## Planning Commission Staff Report

**Subject:** Amended Architectural Elevations  
**Meeting Date:** September 26, 2011  
**From:** Justin Wyse, AICP, Senior Planner  
**Location:** Chesterfield Village Mall  
**Applicant:** Accent Construction Management  
**Description:** Chesterfield Village Mall – American Girl

American Girl  
St. Louis, MO  
Architectural Review Board Package

Proposed Hardscape Layout

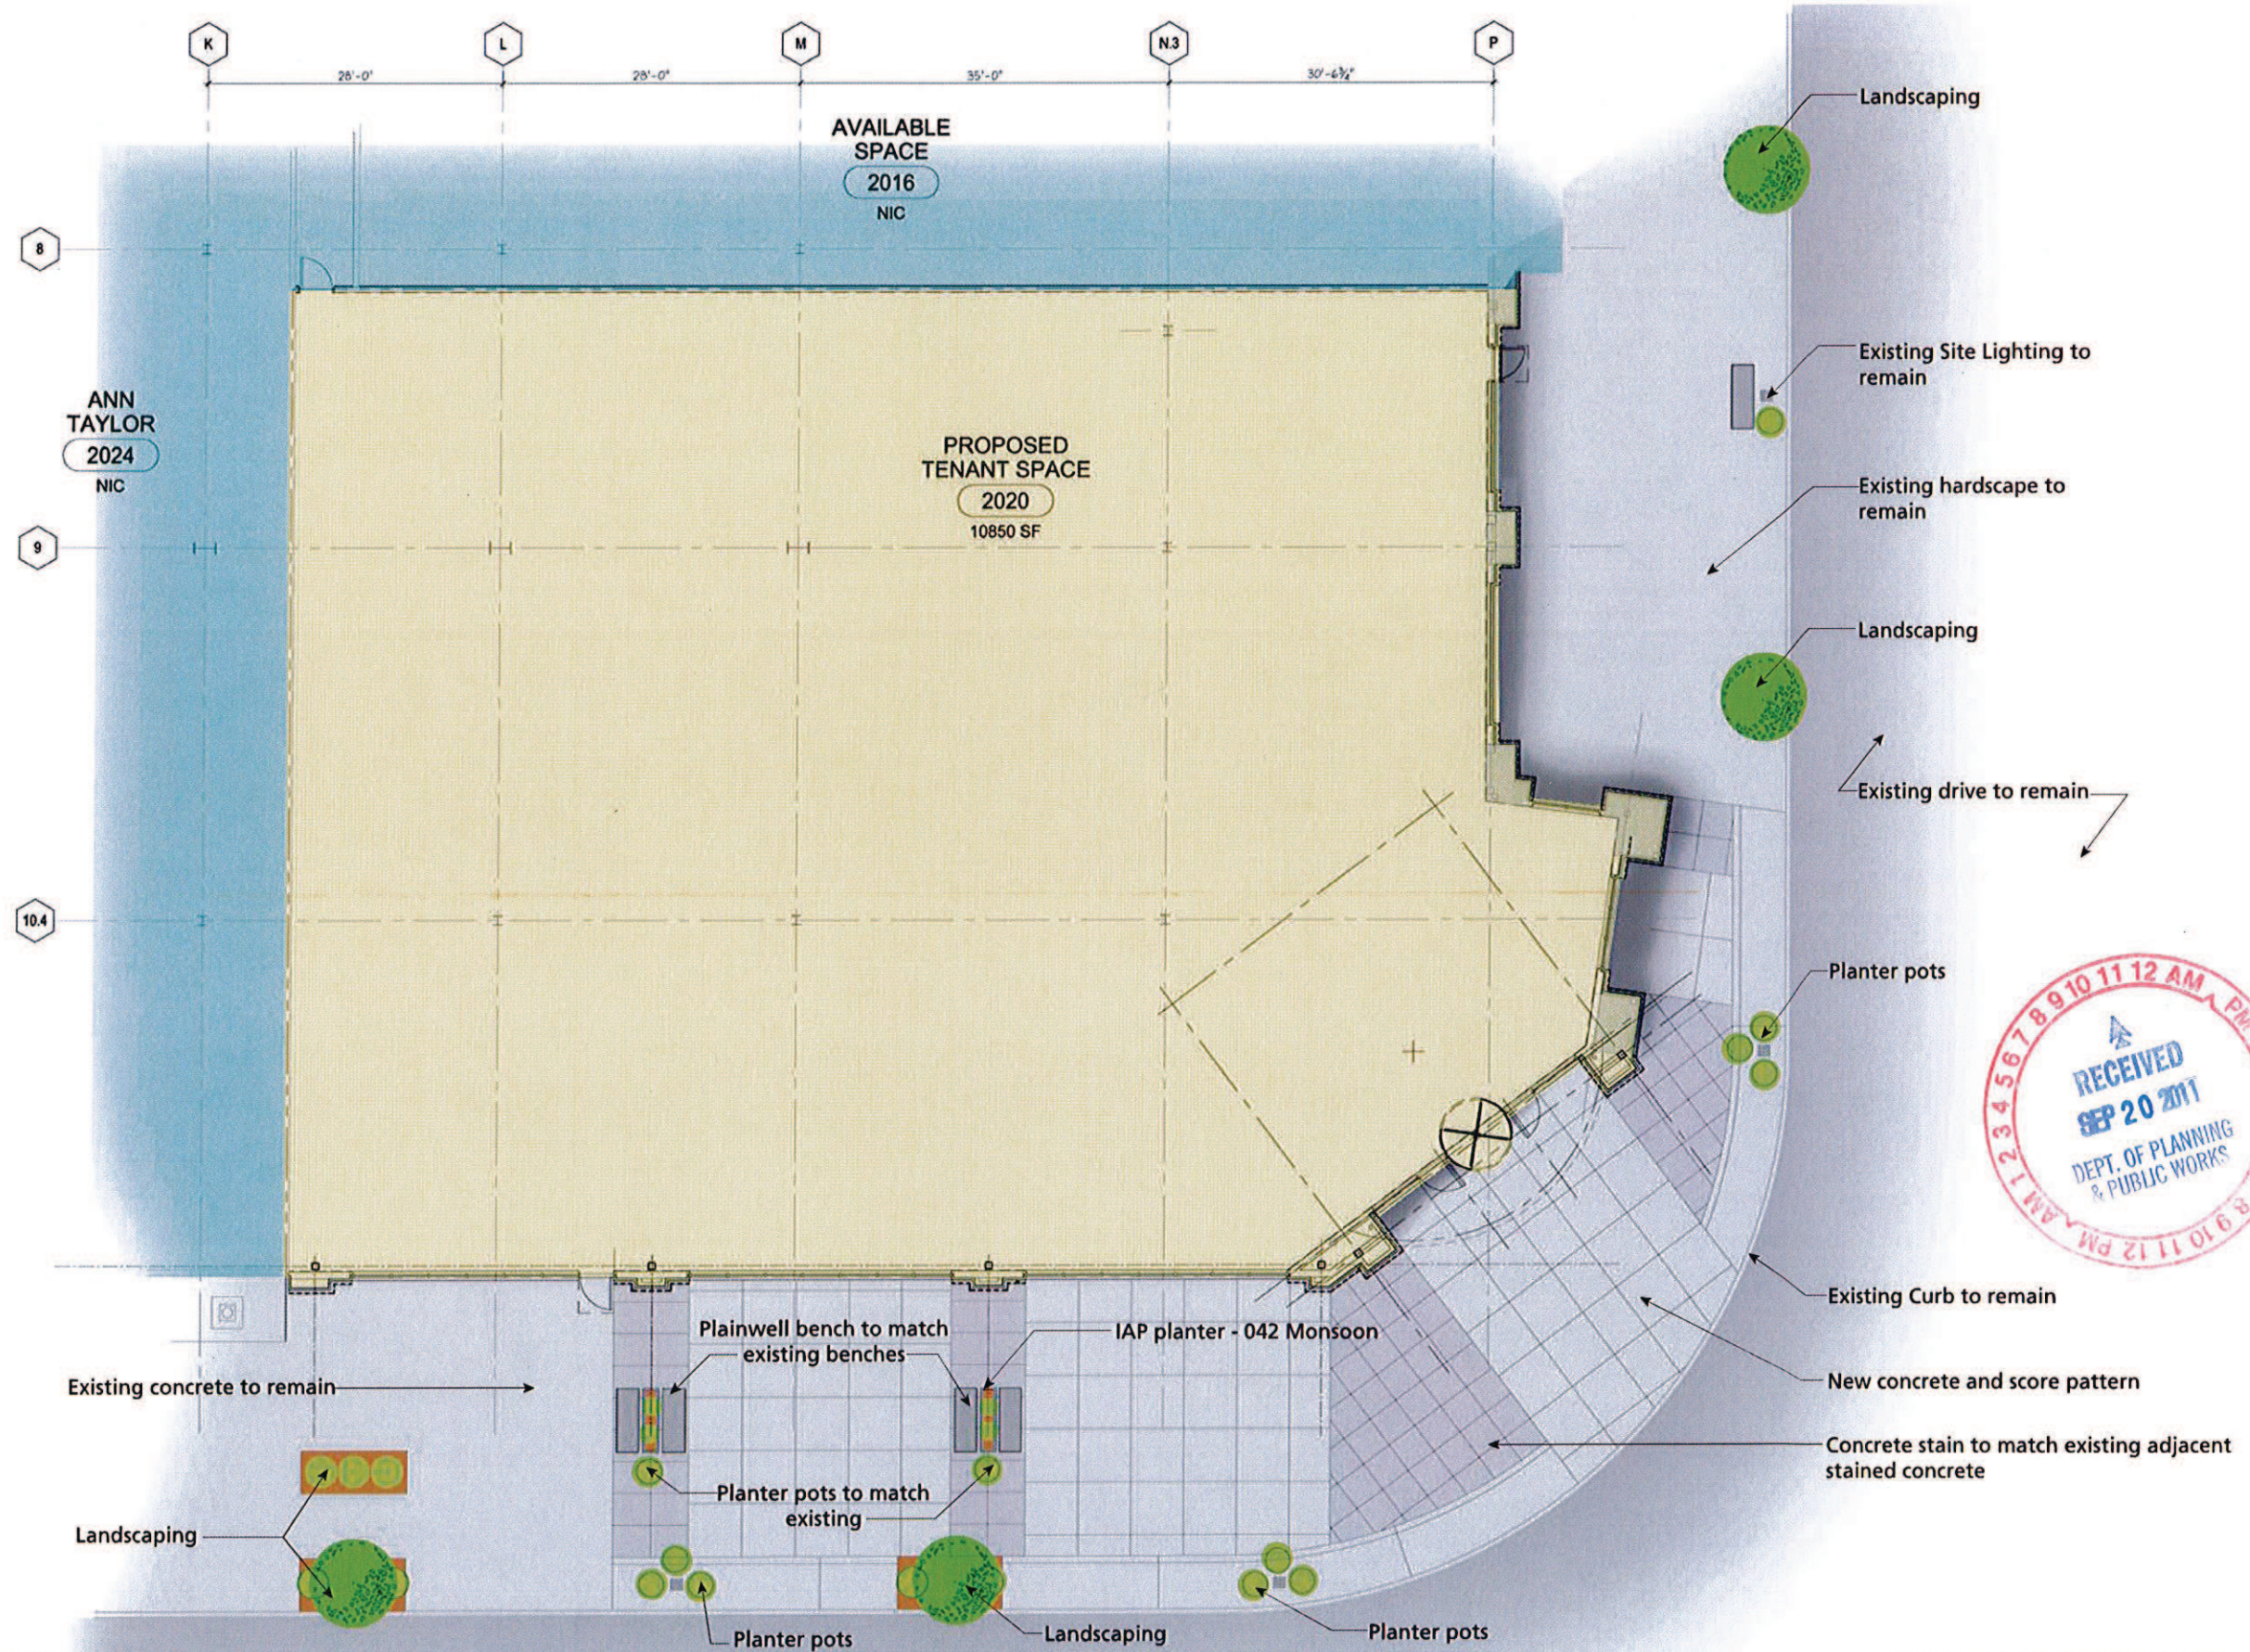
1. *Once the existing streetscape and planting elements are removed from the front façade, a vast open area will be created that will need to be broken up with some architectural, landscape or streetscape elements such as plantings, seating, large scale moveable planters, etc., to improve the human scale and interest along that area. This will also add some visual interest to compensate for removing the curved wall and replacing it with straight walls.*

The Board acknowledged that this was a retail tenant and visibility is important. The Board expressed their opinion that some improvements in this area could still maintain visibility required for retail tenants while enhancing the exterior tenant space. To address this recommendation, the applicant has submitted a

plan that includes planters similar to existing planters at the mall (18), trees (2), rectangular planters (2), benches consistent with the style of the existing benches (4), and new concrete with a score pattern. The proposed enhancements are shown on the Proposed Hardscape Layout included in your packet.

Composite Elevations

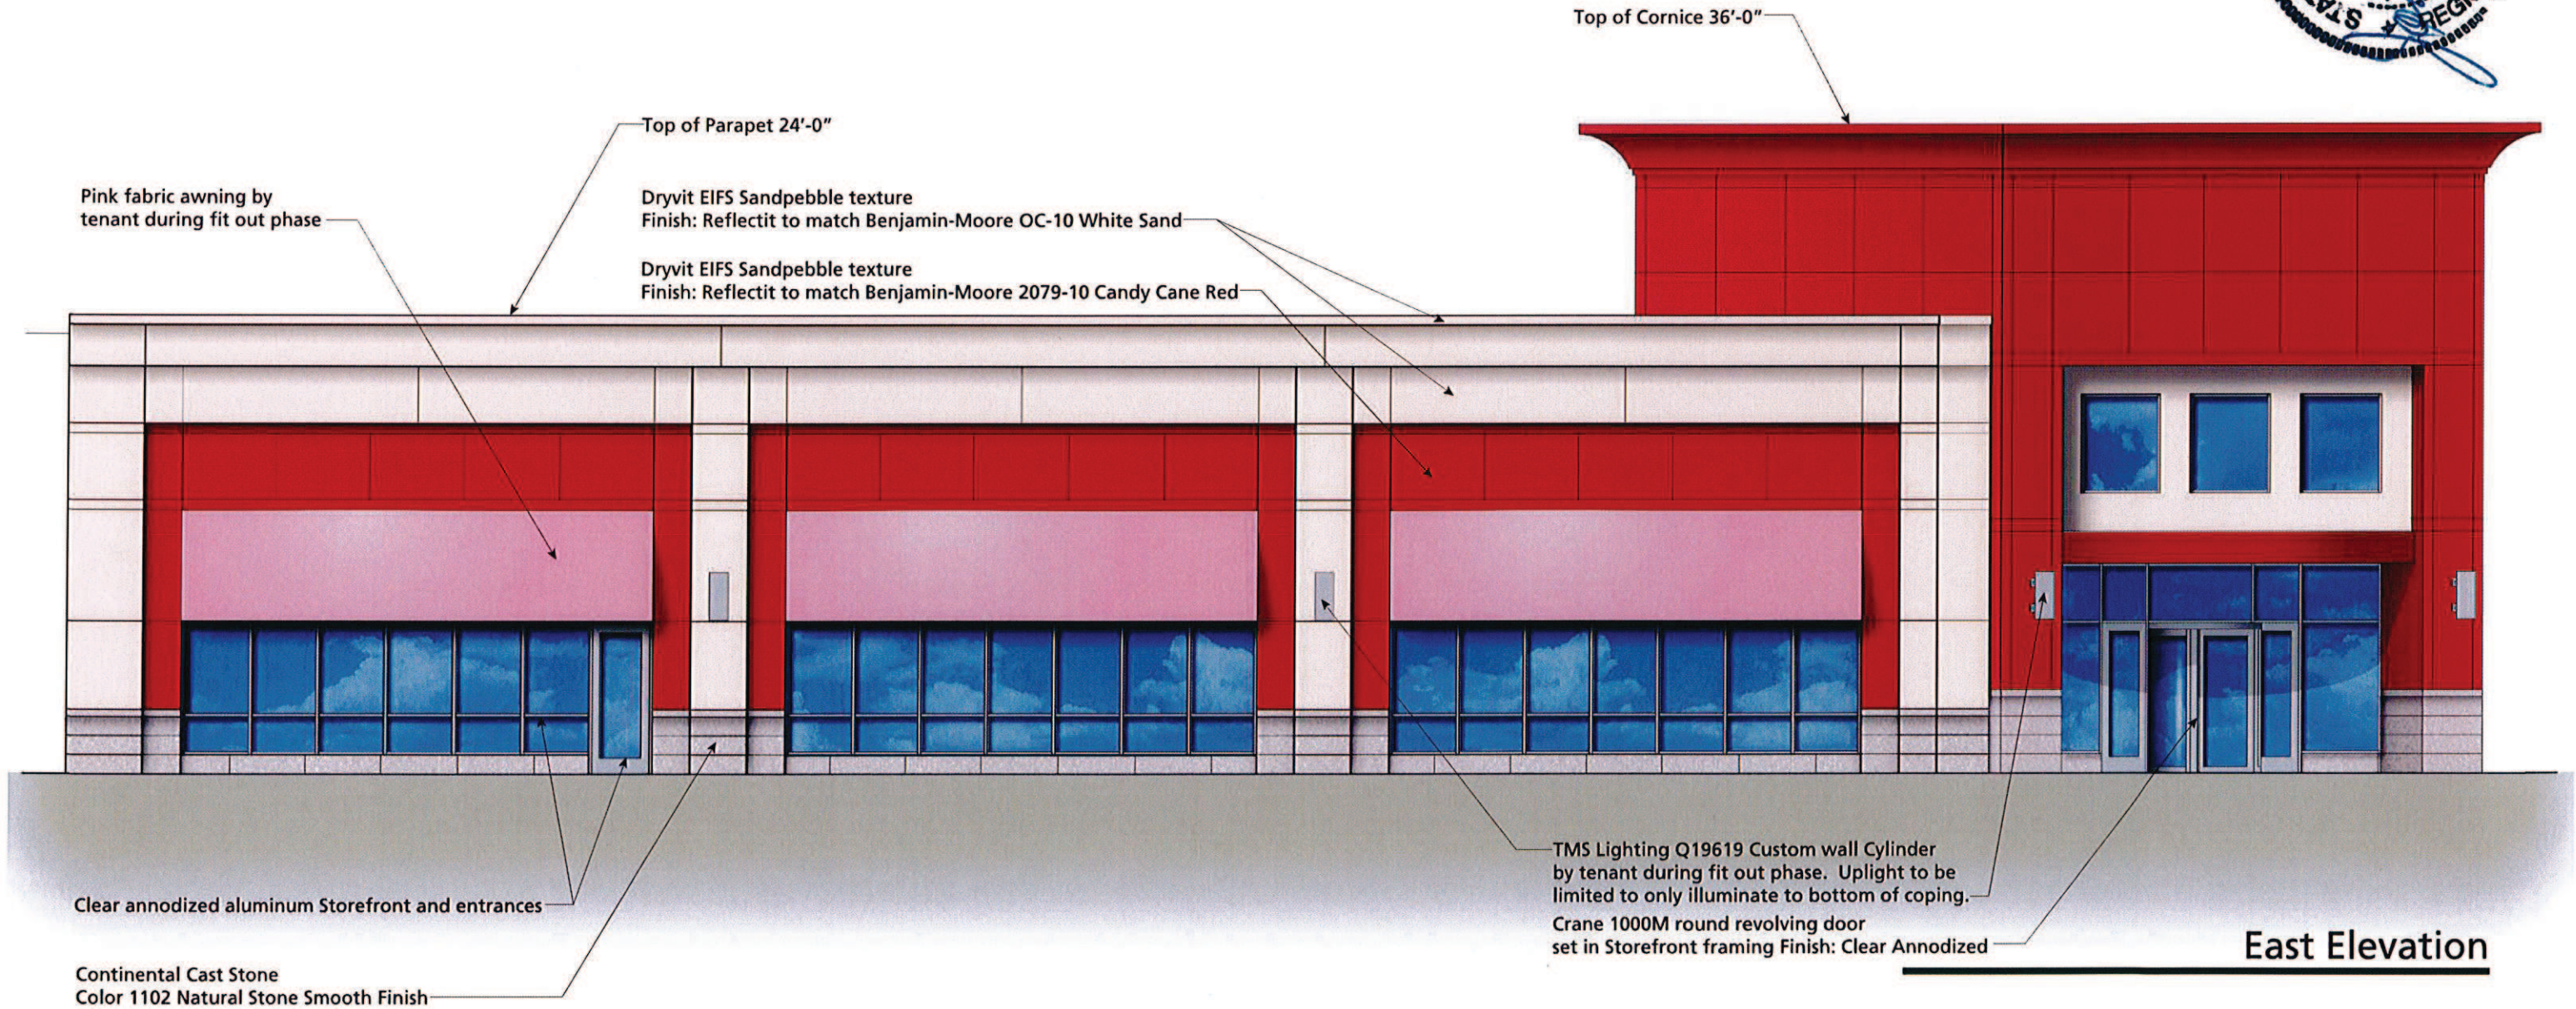
2. *The Board would like the petitioners to strongly consider changing the EIFS at the top corner of the building's front entryway to match the cast stone or sand white color in order to break up the façade. This will also help to tie in the building architecturally with the surrounding mall.*

The Board discussed that they were aware of the potential that the tenant would not be receptive to this idea as the color scheme is a trademark of the American Girl stores. As indicated by the motion above, the Board did not state that the applicant should be required to make the recommended change, but rather, suggested to the applicant to make change.

The tenant was contacted regarding their willingness to make this change; however, they have decided to continue without incorporating this modification. No changes are being proposed to the color of the cornice.

TMS LIGHTING - LUMINAIRE APPROVAL DRAWING  
Q19619 CUSTOM WALL CYLINDER  
TYPE: REV.

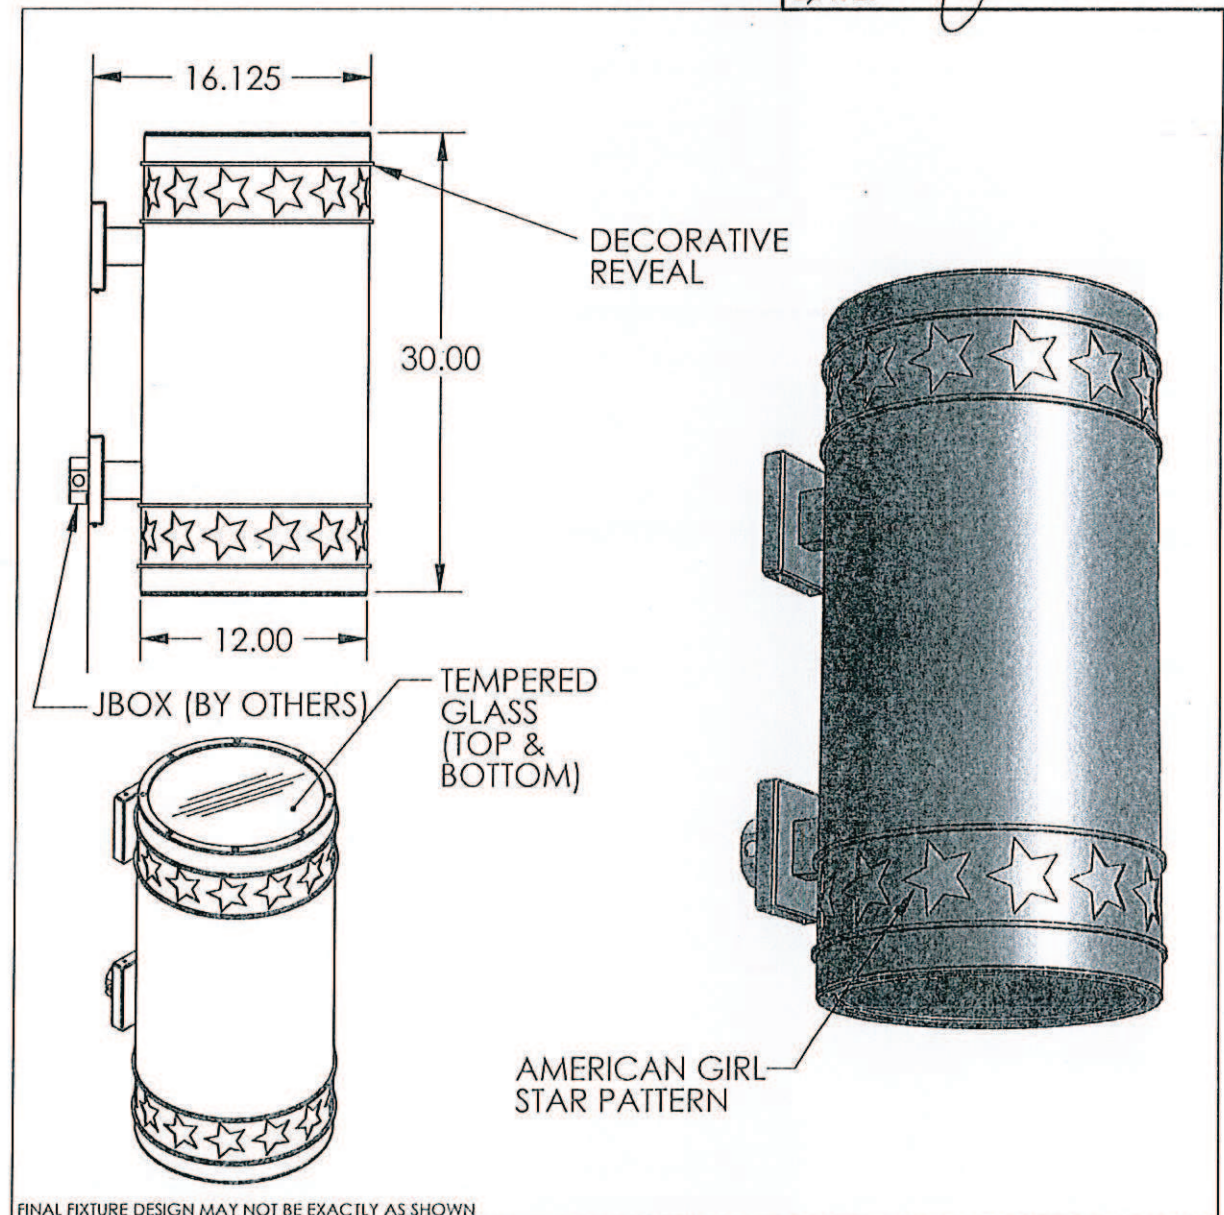
New wall mounted light fixtures will be proposed on the exterior of the tenant space. The fixtures will be modified from their original design to include shielding to ensure light does not extend beyond the roof line in compliance with the City of Chesterfield Lighting Ordinance.

The design of the new American Girl store at the Chesterfield Mall includes exterior sconces. These custom light fixtures are designed to cast light on the façade in both the up and down directions, for a decorative effect. They are not intended to illuminate walkways or drive aisles. We understand that City of Chesterfield Ordinance 2228 prohibits up-lighting, unless the applicant can show that the building will block light from extending past the top of the building. Therefore, we intend to modify the design of these fixtures to include a shield that will restrict the light emitted from the top of the fixture, and ensure that it is cut off before it reaches the top of the parapet.
